Access Compliance Report

Public Rights-of-Way

Main Street: BRITTANY_WOODS_DR Cross Street: IRVINE_BLV Location: SE

ADA ID: RPRK211014155227 Ramp Type: Type 4 - Parallel Initial Pass/Fail: Pass Overall Compliance: No Severity Score: 0

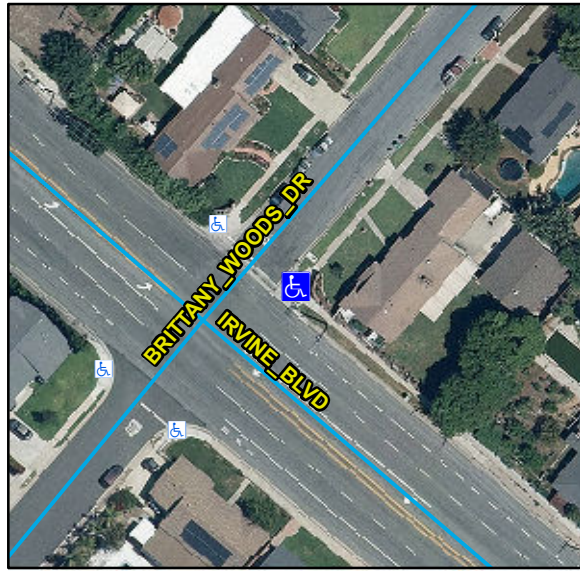
Remove & Replace Curb Ramp With Two New Directional Ramps or Equivalent.

R304.2.2, R204.3, STD 1115
